**ERDC/CRREL TR-00-13**

# **Assessment of Millennium Pipeline Project Lake Erie Crossing**

**Ice Scour, Sediment Sampling, and Turbidity Modeling**

Prepared for  
MILLENNIUM PIPELINE COMPANY

Figure 6.3. Progression of scouring ice keel-trench interaction.

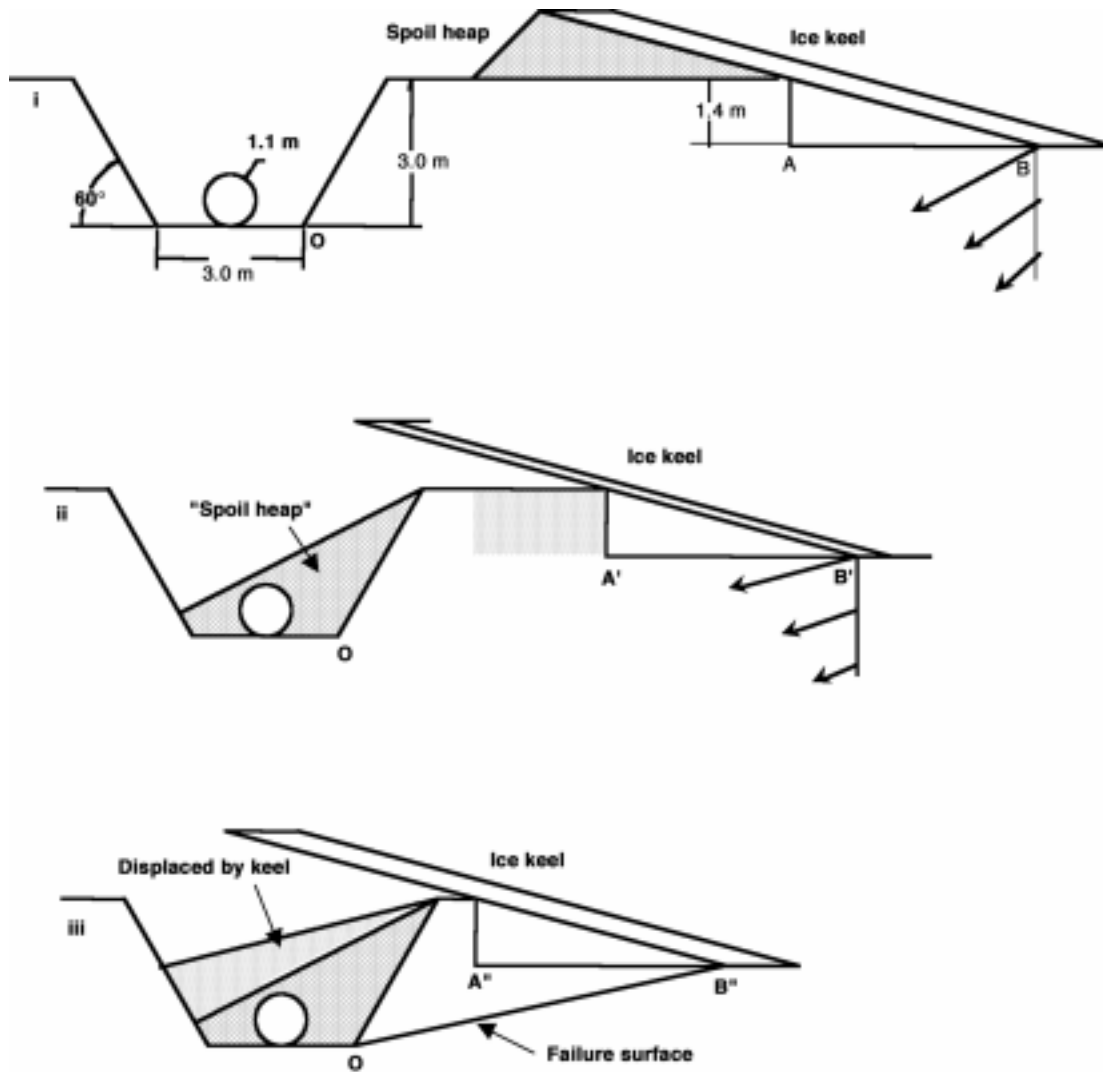
2. *The questions raised in the June 21, 1999 letter from OPE, Inc., to Mr. Heino Prahl (National Fuel 2000) regarding the use of a two-dimensional rather than a three-dimensional analysis should be addressed in greater detail. In the September 1999 C-CORE Contract Report “Comparison of Lake Erie and Northstar Pipeline Designs for Ice Scour” (C-CORE 1999b) there is a short description stating that the ice scour process was simplified as a two-dimensional problem... “and tabulation of the number of degrees of freedom of the pipe finite elements of both the C-CORE and Northstar analyses.” It appears that the Northstar analysis used a three-dimensional approach, yet this is not discussed. We would appreciate clarification of this. Also, what are the consequences of using a 2-D rather than 3-D analysis?*

An ice keel with an attack angle of 15-degree scouring to a depth of 1.4 m (4.59 ft) and a width of 14 m (45.9 ft) is considered as shown in Figure 6.3i. This

The sub-gouge deformations are assessed from the PRISE program as shown by Woodworth-Lynas et al. (1996). The free-field sub-scour soil displacements accumulate from points A' to B' i) of Figure 6.3. The sub-scour displacement vectors are shown at three elevations under point B'. At the pipe spring-line elevation, the deformation vector magnitude is 6.2 ft. It should be noted that the free-field horizontal component is 5.1 ft, which is a very large percentage (82%) of the total deformation. This percentage increases significantly as the vertical deformation component is reduced through interaction with the trench and its infill.

**CRREL:** The response clarifies the use of a two-dimensional horizontal-loading analysis via a convincing qualitative argument. It also clarifies the conservatism built into the analysis arising from the analysis' assumption that the free-field horizontal deformation governs the pipe loading.
